**Central Hall Phase 4 – 2<sup>nd</sup> Floor Tenant Improvements (ITB 2026-06)**

**April 9, 2026**

**Addendum #2**

MECHANICAL SCHEDULES

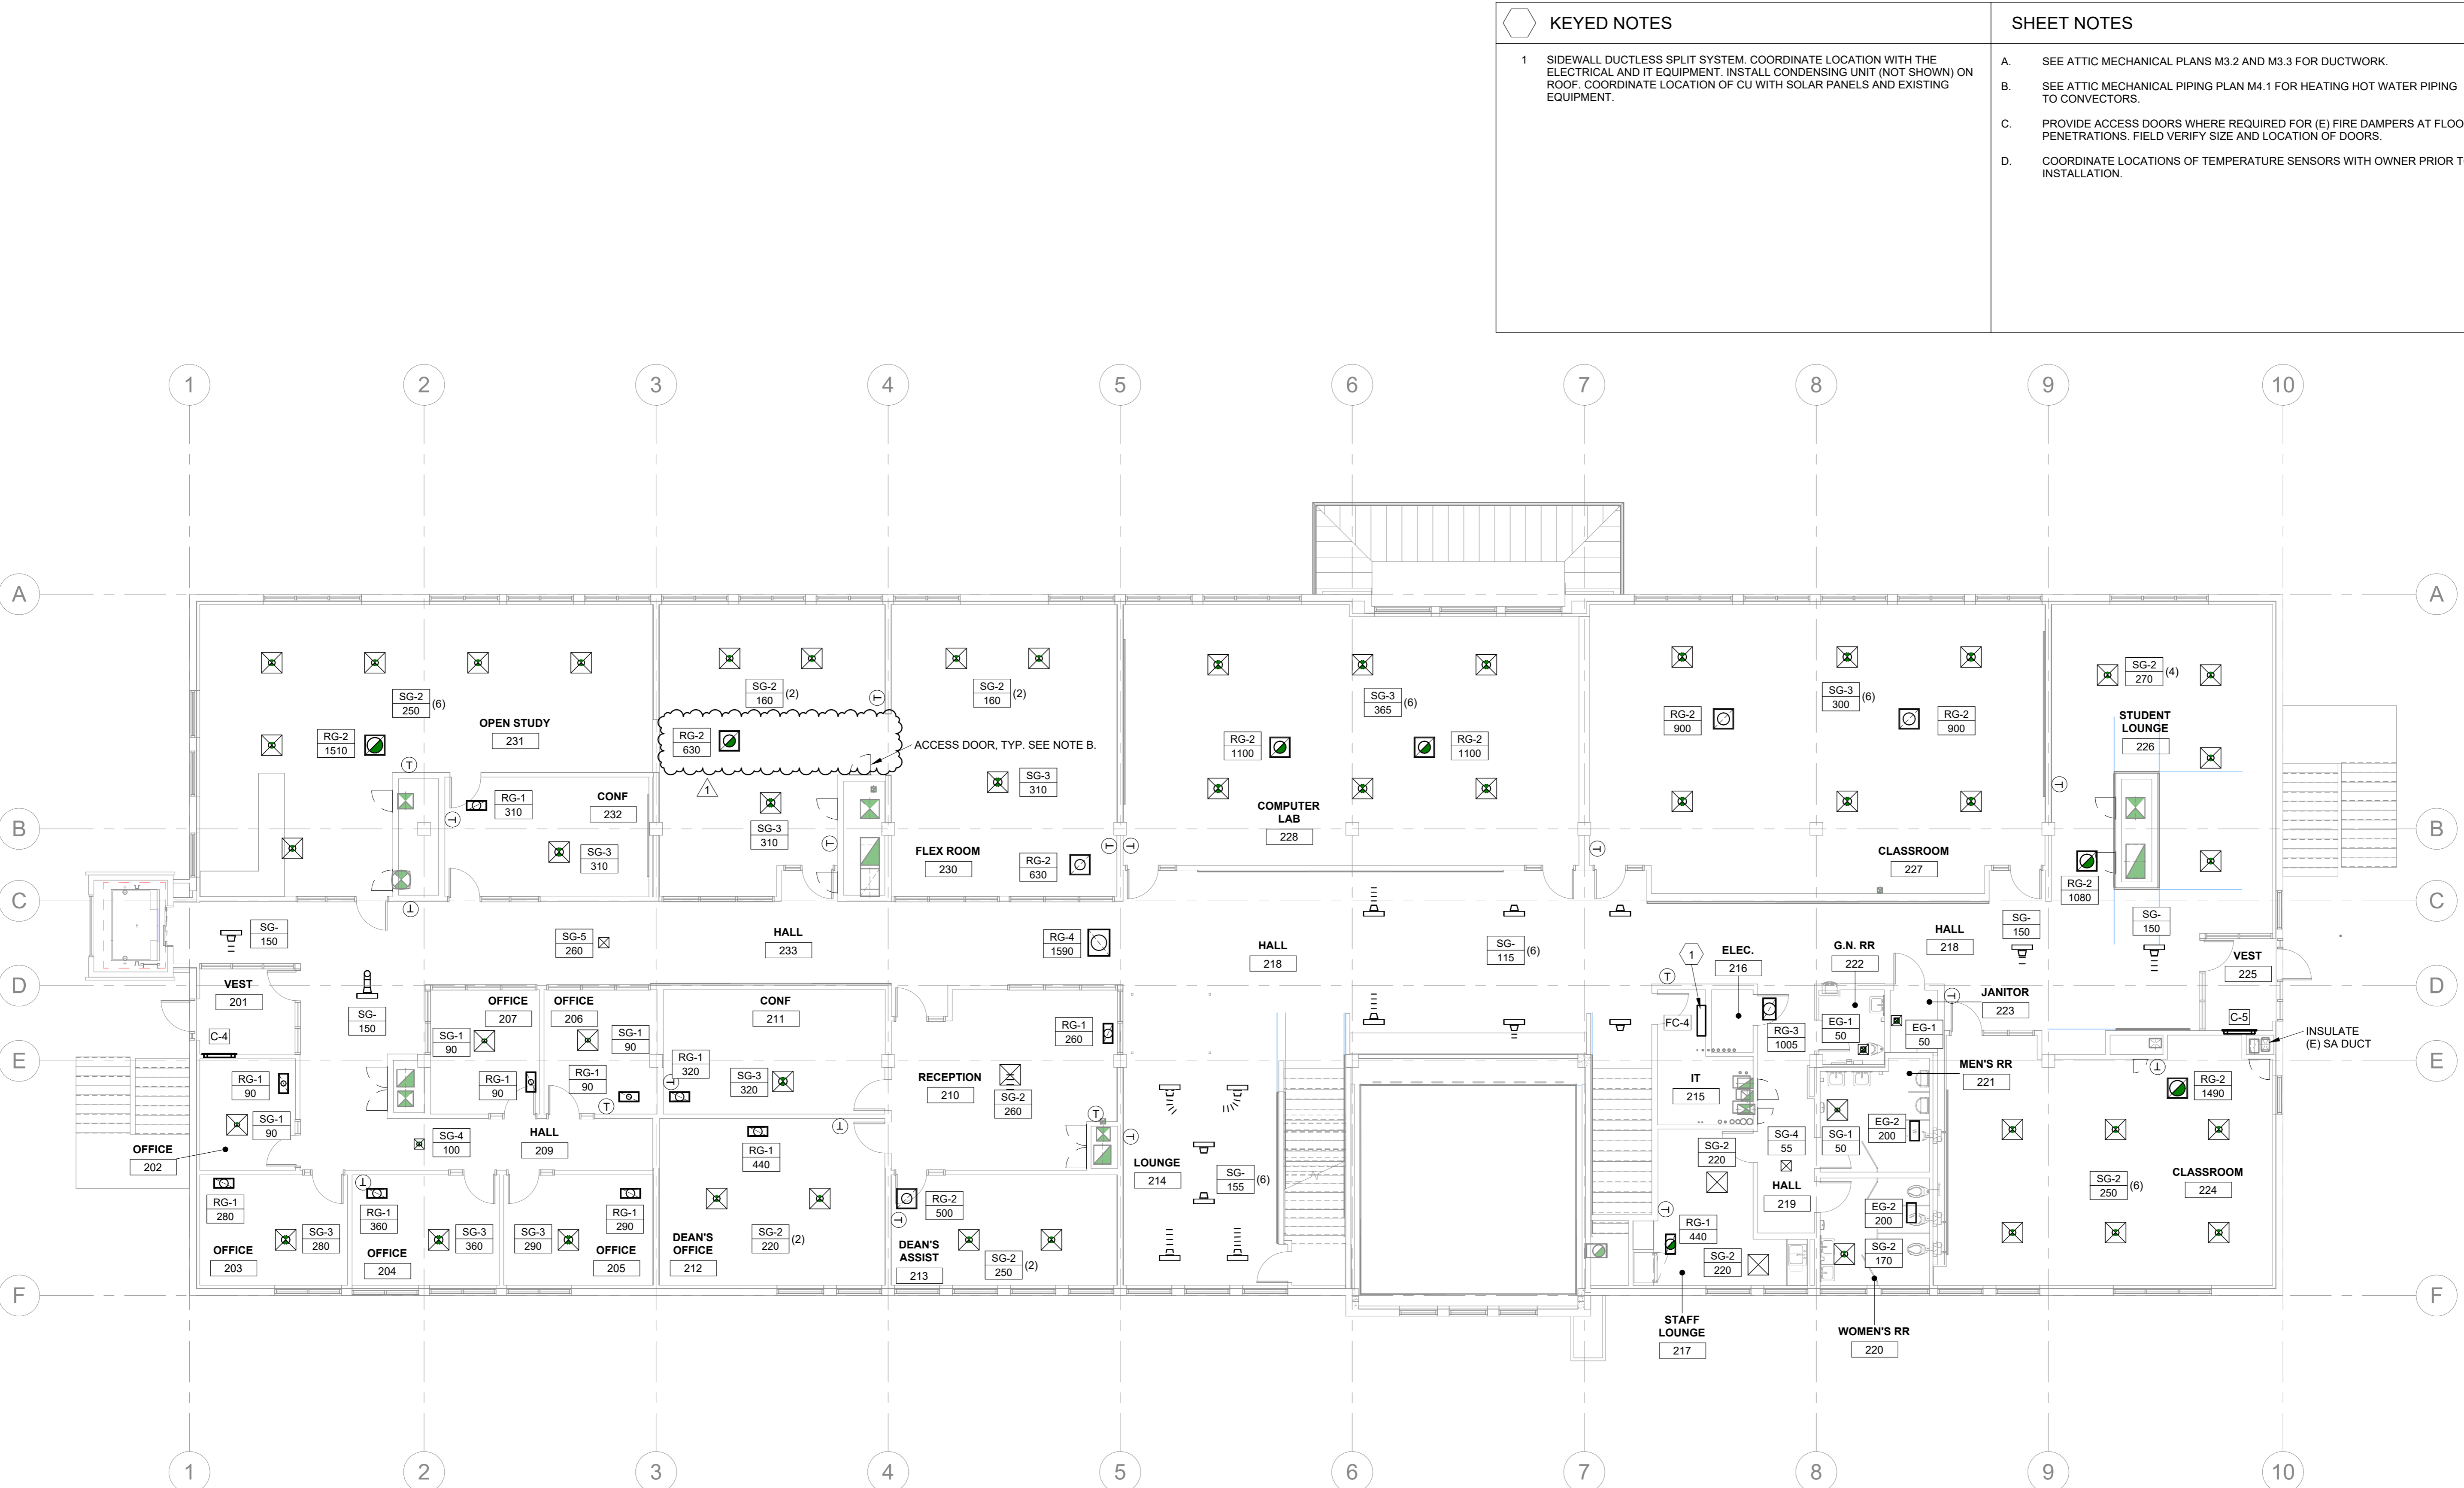
1. Refer to the revised HVAC drawings (attached) for changes to ducting, sound attenuators and HVAC access doors. Piping details have also been included on M4.1.
